UNITED STATES OF AMERICA
NUCLEAR REGULATORY COMMISSION

In the Matter of)
) Docket No. 50-344
PORTLAND GENERAL ELECTRIC COMPANY, ET AL.) (Control Building)
)
(Trojan Nuclear Plant))

NRC STAFF REVISED TESTIMONY OF KENNETH S. HERRING AND
DREW PERSINKO ON THE STRUCTURAL ADEQUACY OF THE
PROPOSED MODIFICATIONS TO THE TROJAN CONTROL BUILDING

FIGURE 1

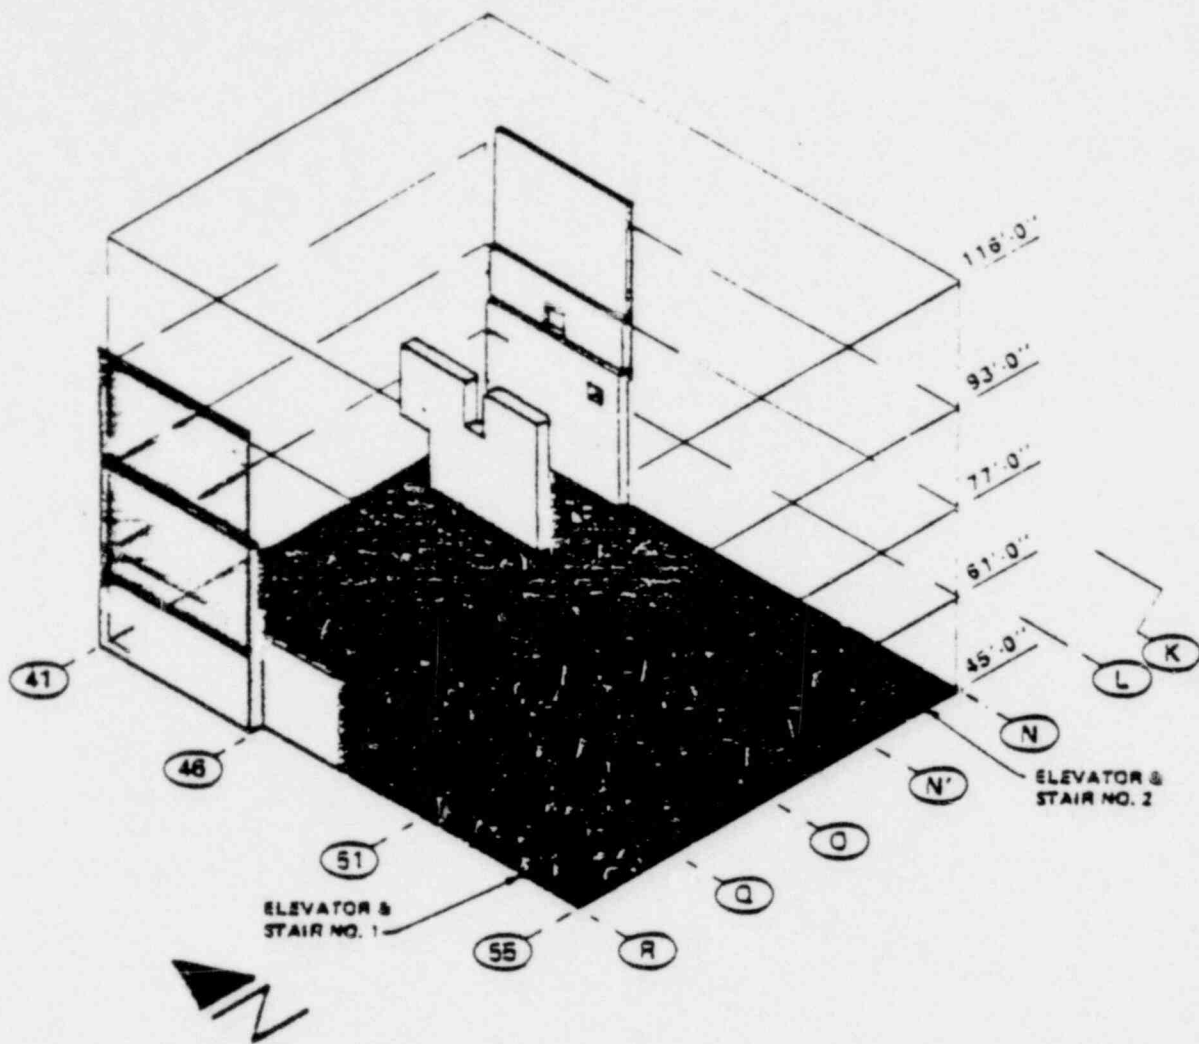
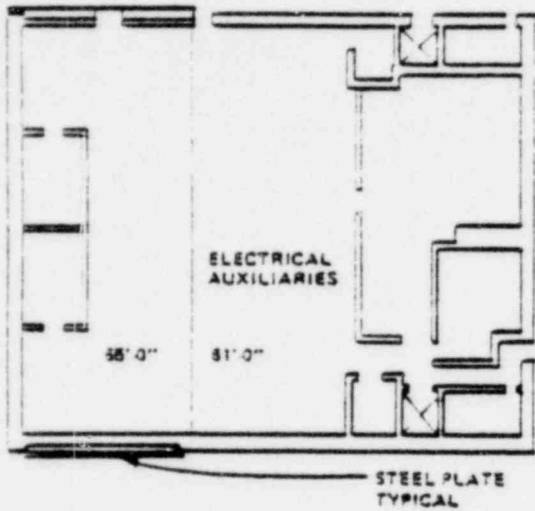
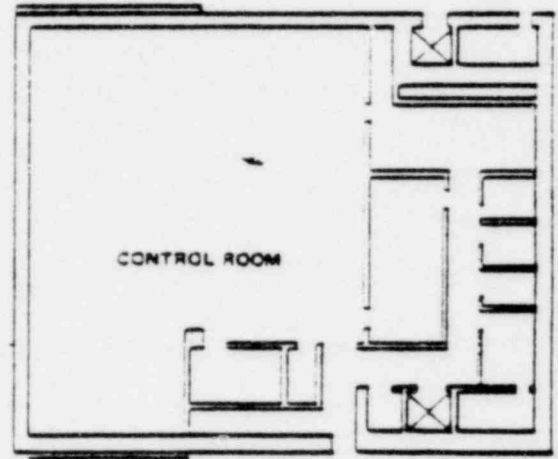
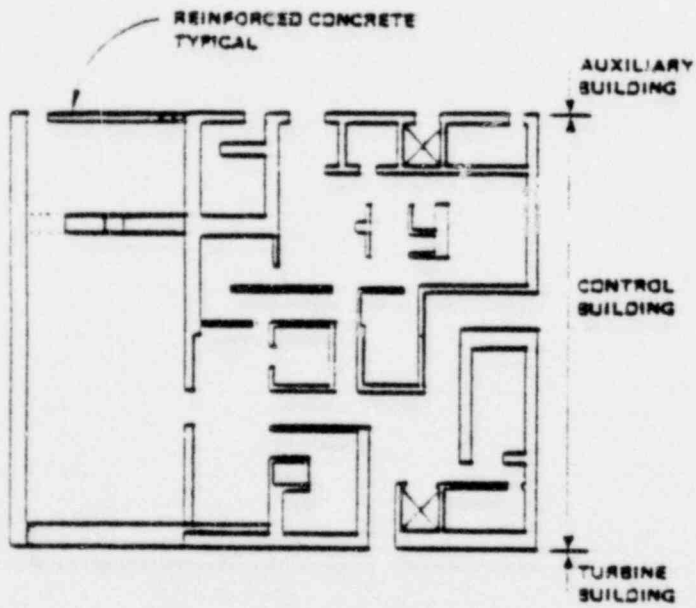
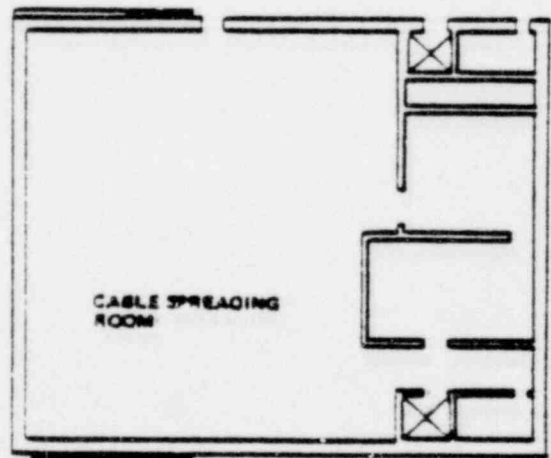
As shown on the attached Figures 1 and 2, the Control Building modifications consist of the addition of three new reinforced concrete shear walls across the existing railroad bay in the Control Building. Part of the new west wall would extend south of column line 46 into the existing locker room at elevation 45'. In addition, part of the west wall would be further strengthened by the addition of a three-inch thick steel plate bolted to the outside of the wall between elevations 59'-3" and 97'-3" with high-strength steel bolts.
